APPALOOSA HIGHWAY 24 SUBDIVISION

FILING NO. 2

COVER SHEET

Markup Summary

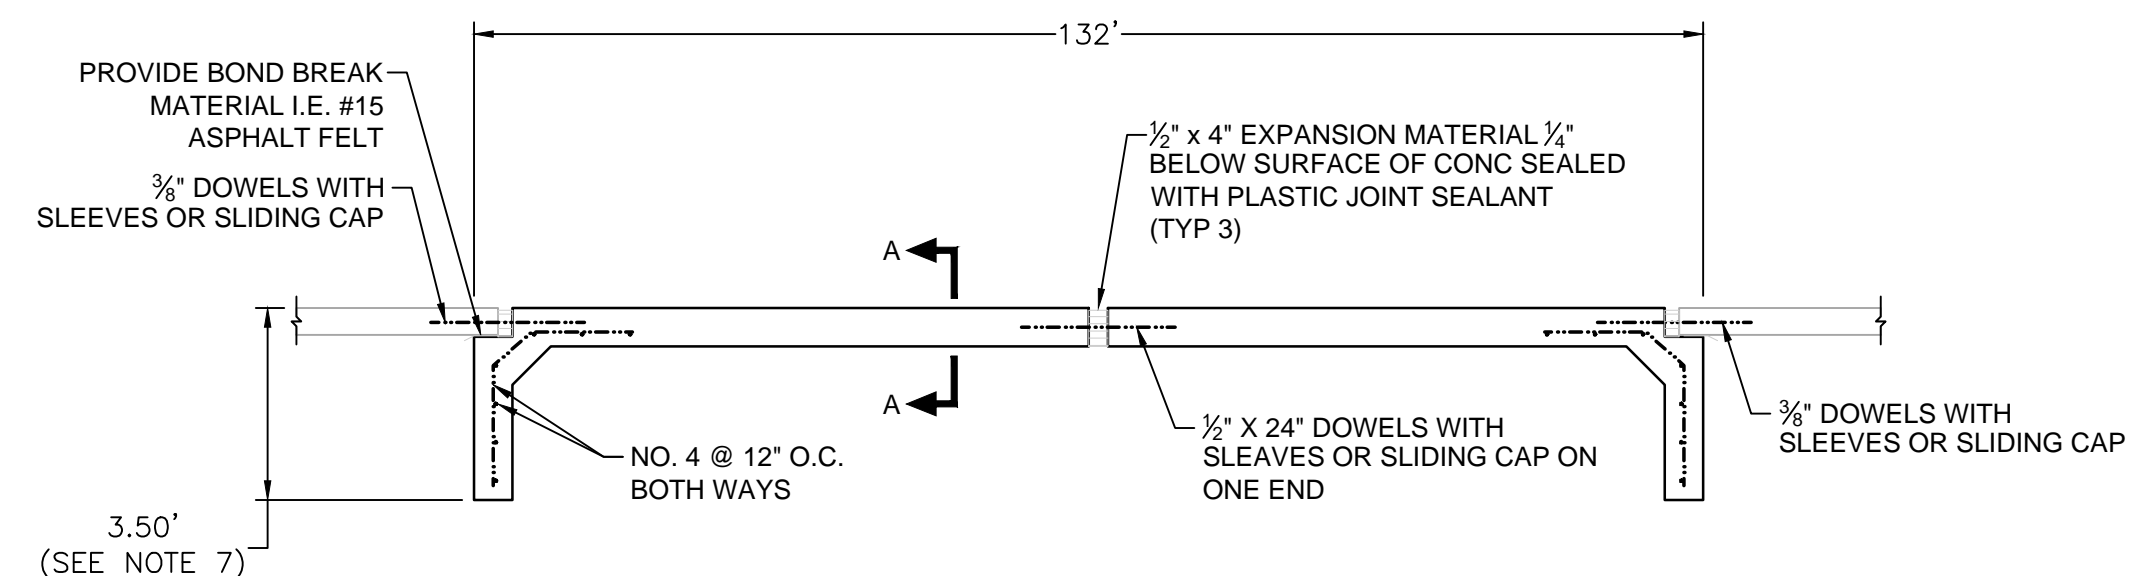
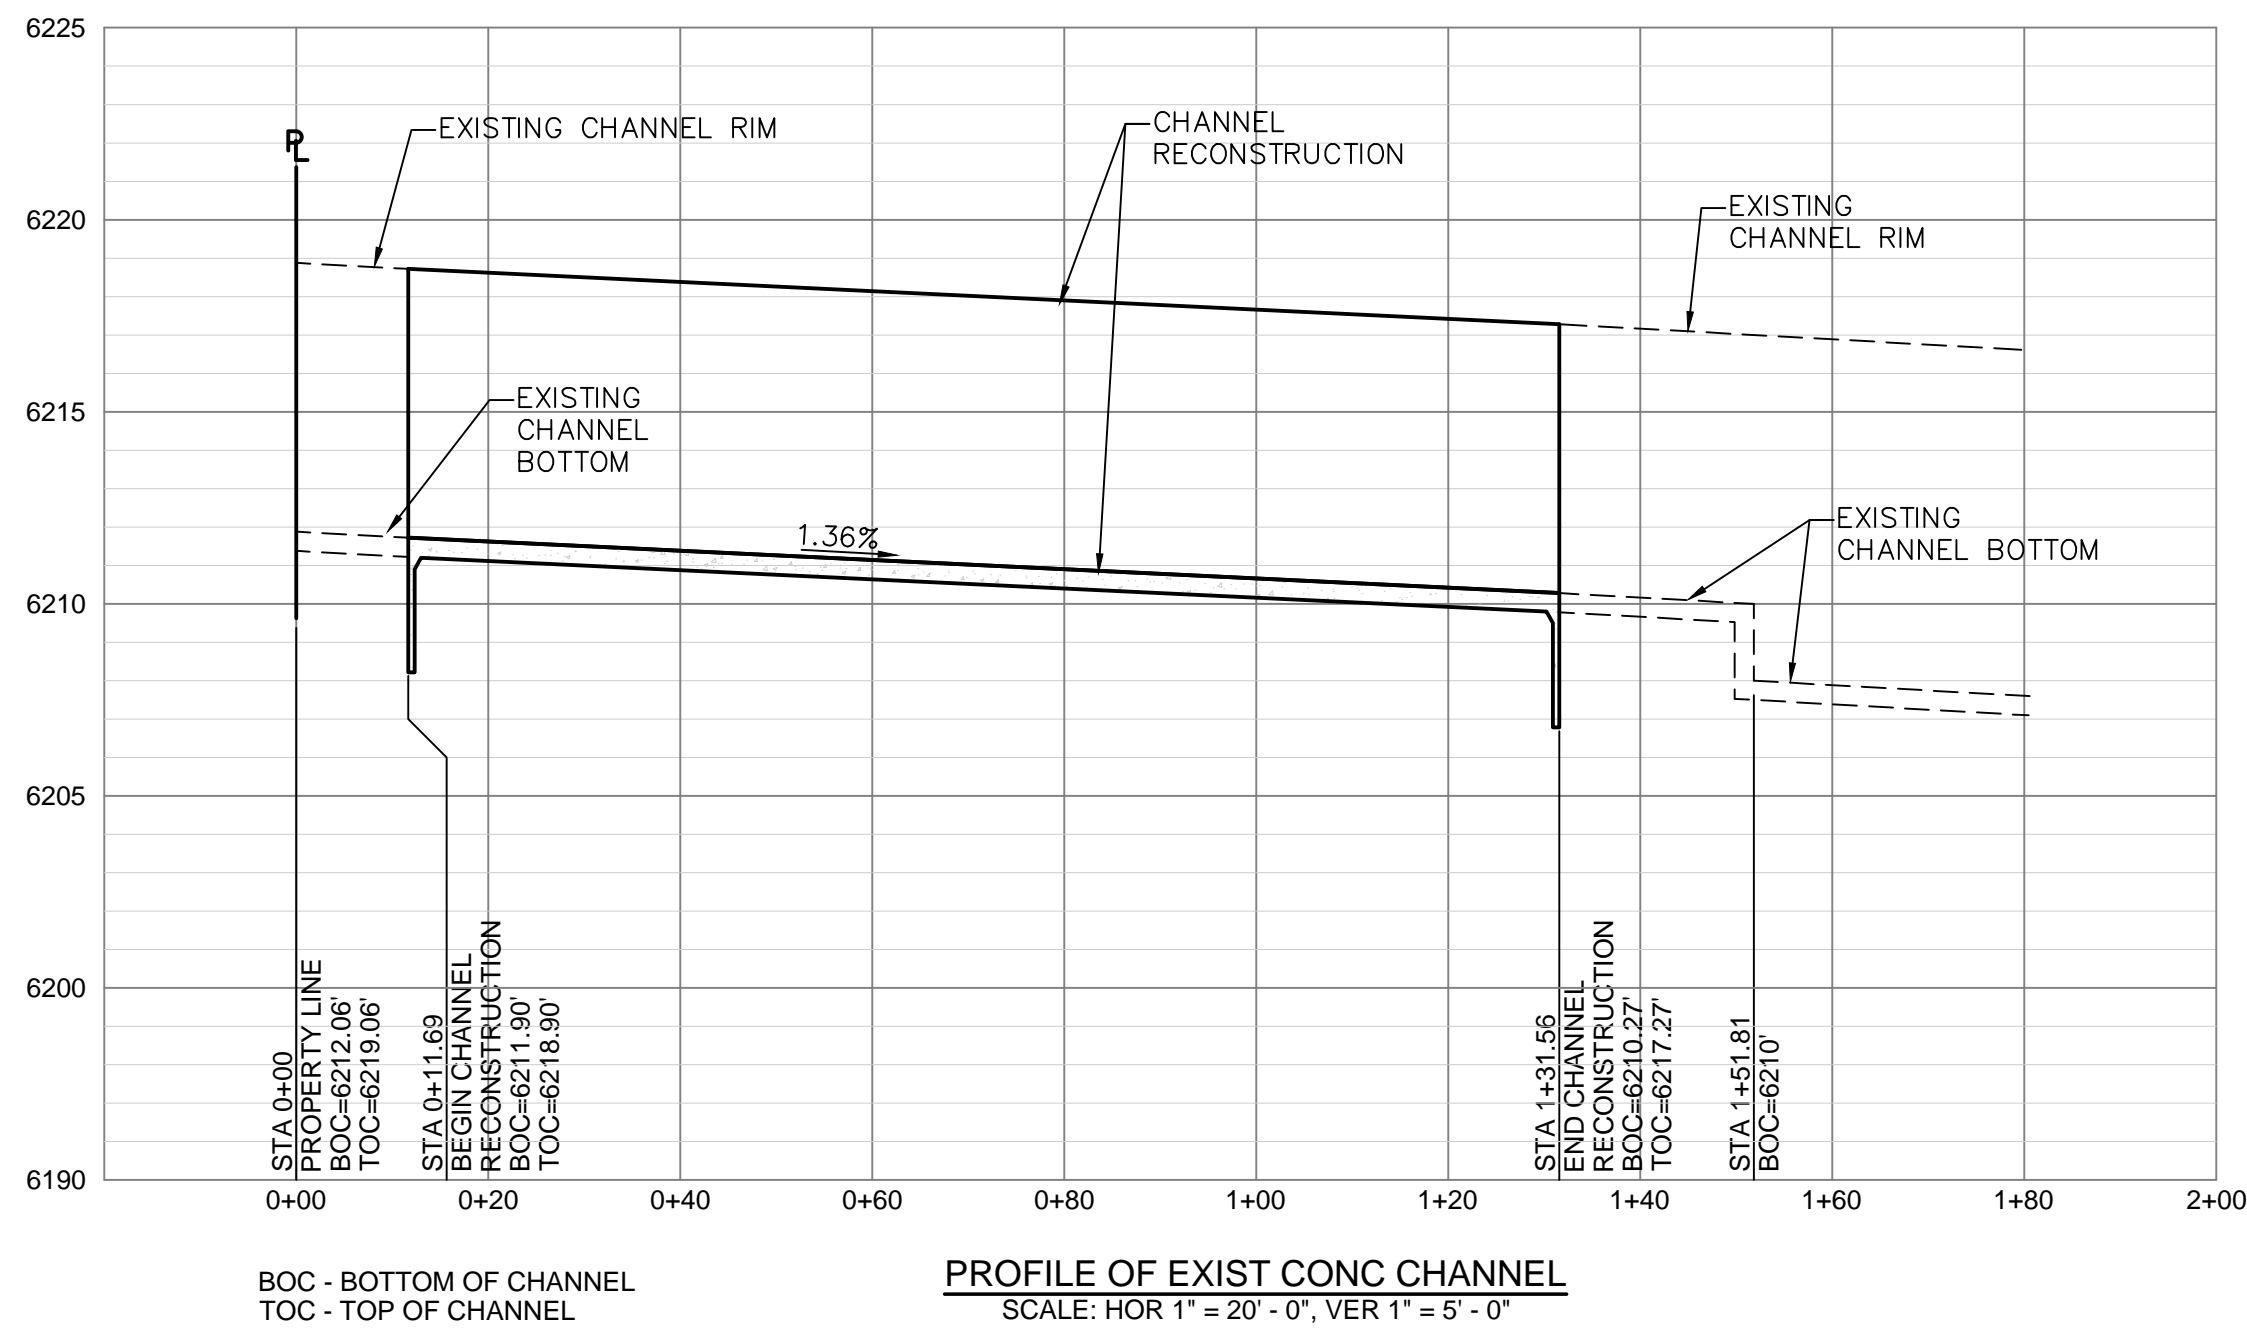
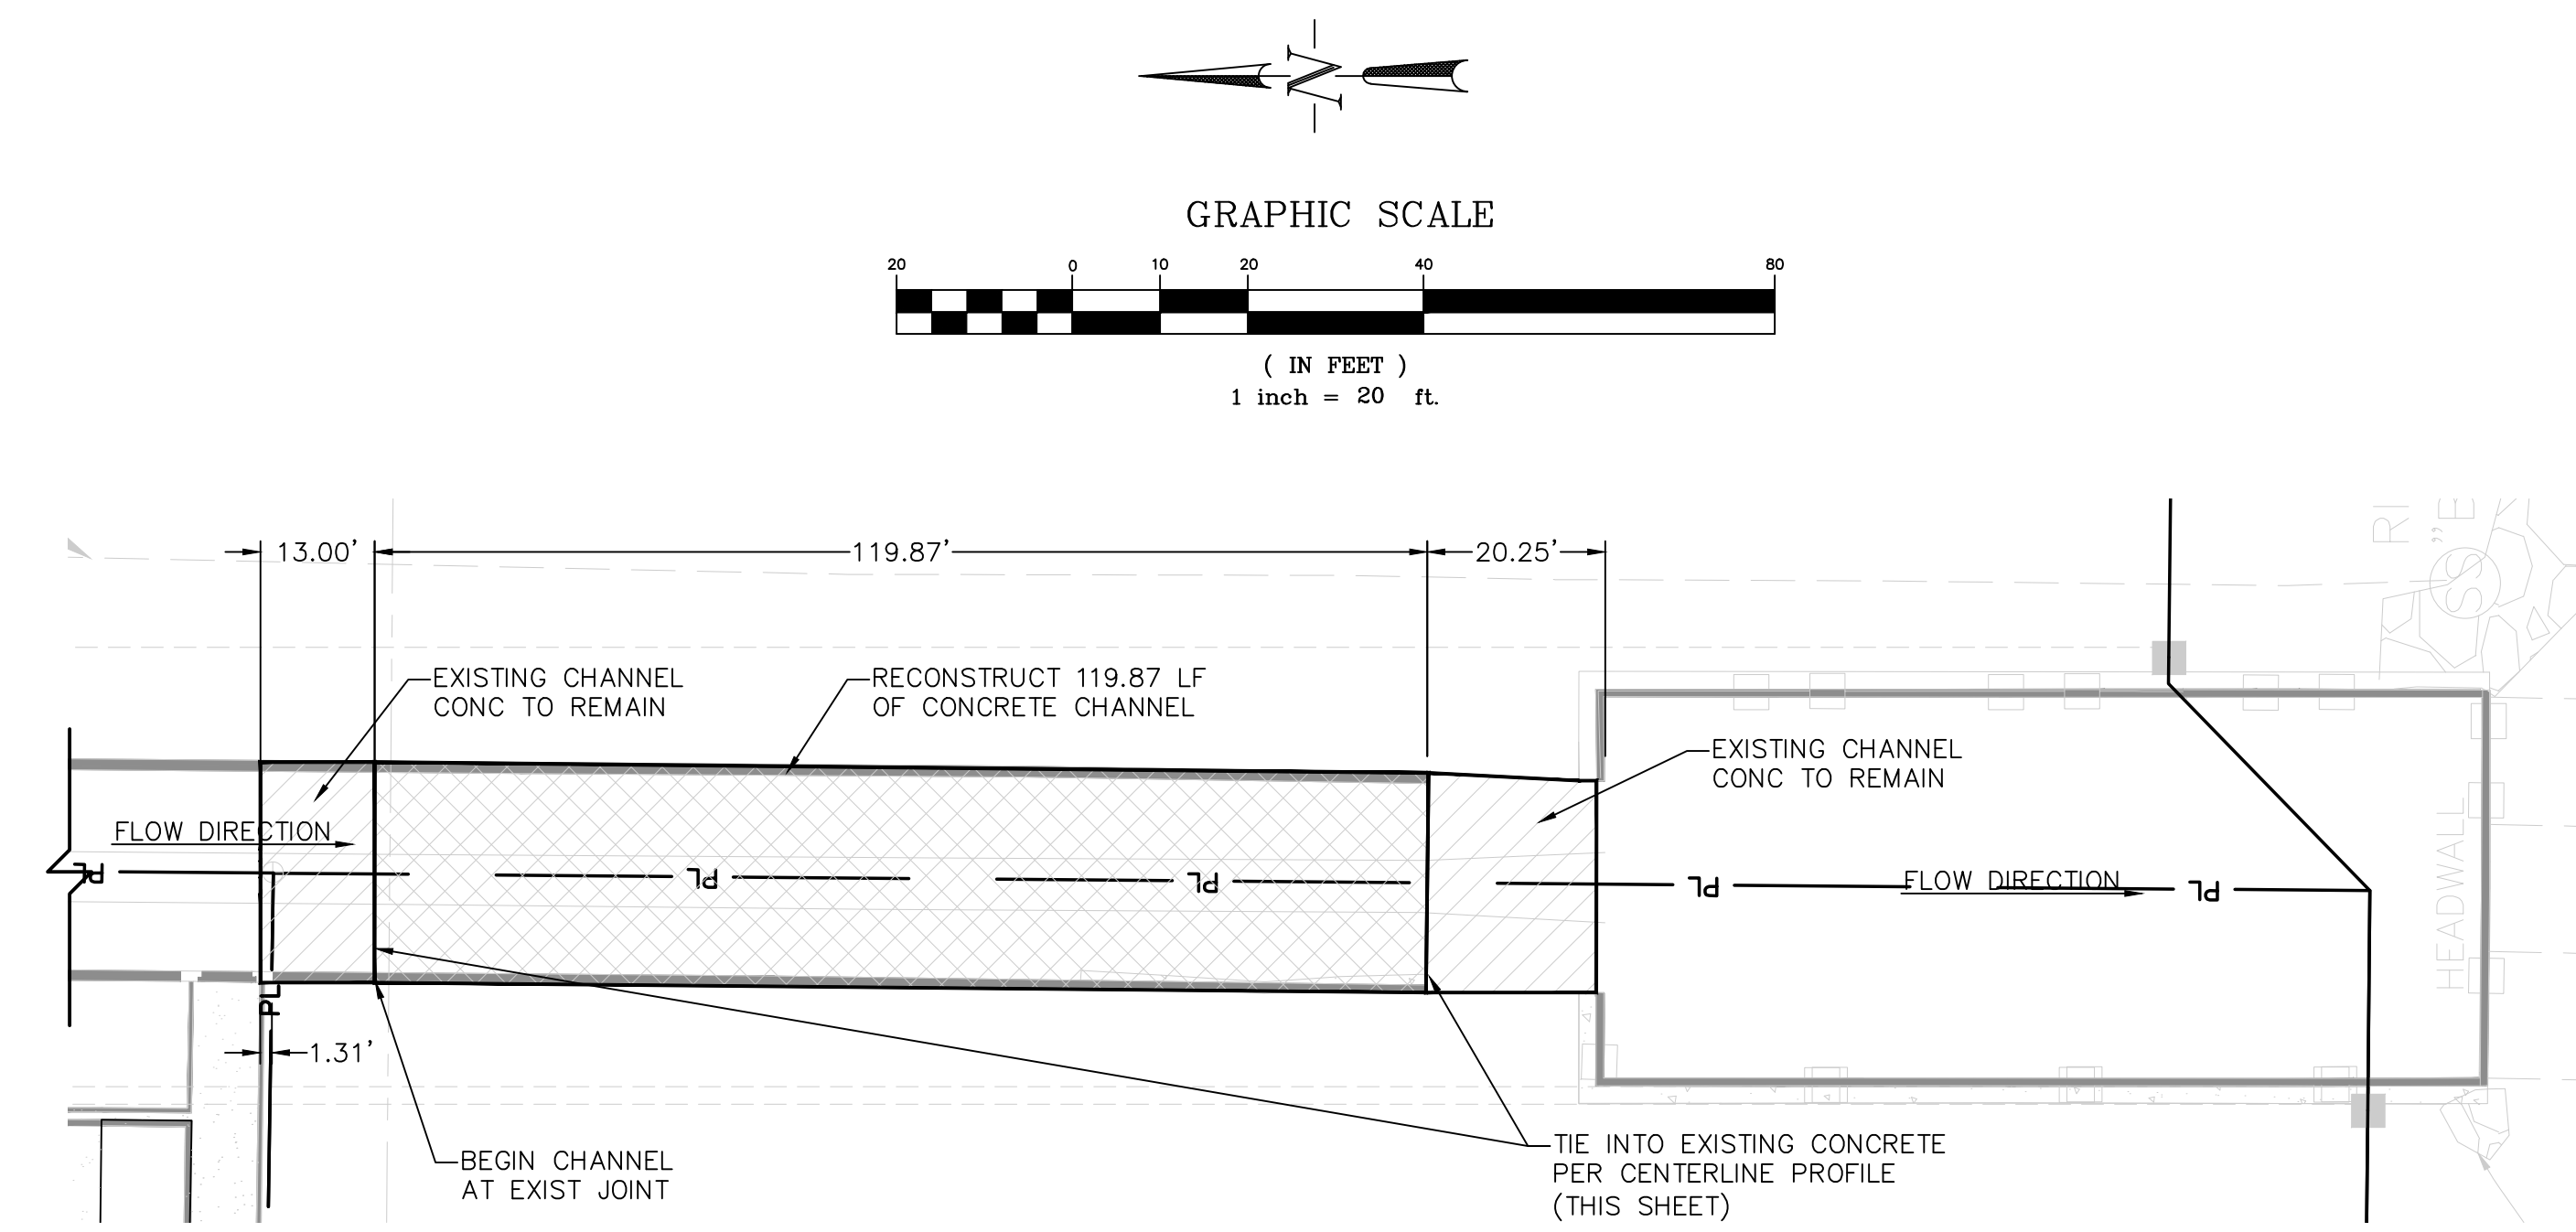
The outfall pipe must be within a drainage easement

Show all construction BMPs. Construction BMPs are currently not shown on the plan.

Identify the property line in the legend

CHANNEL PLAN /PROFILE & NOTES

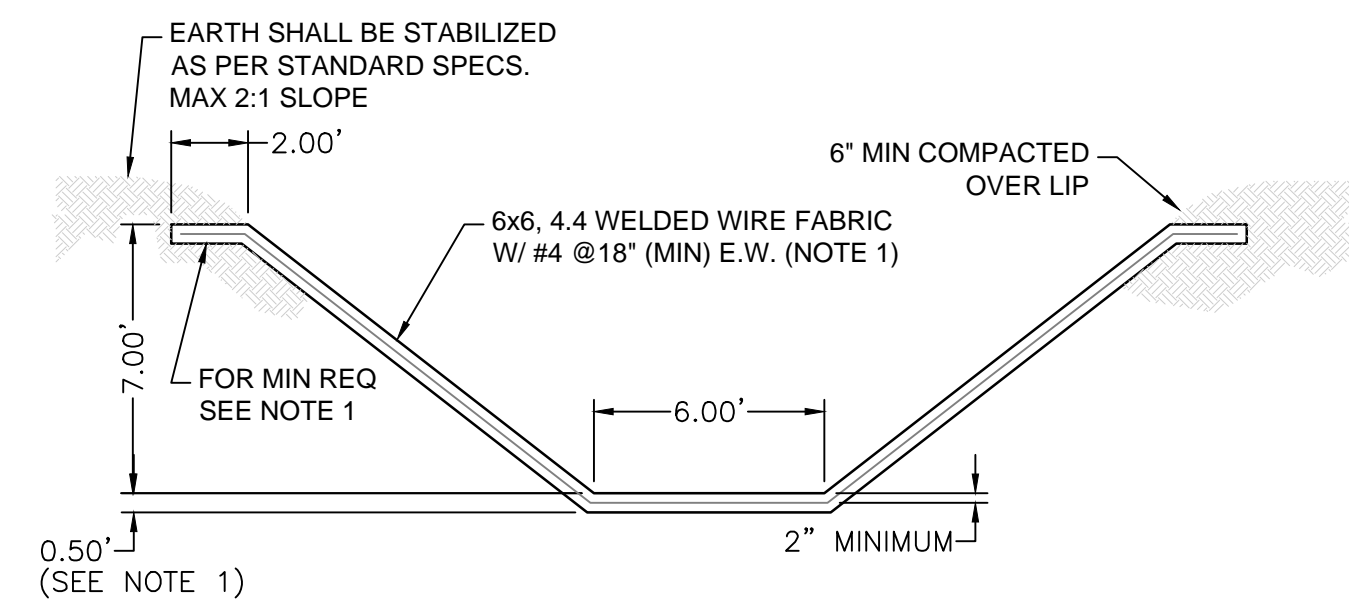
Duplicate from the cover not necessary on this sheet
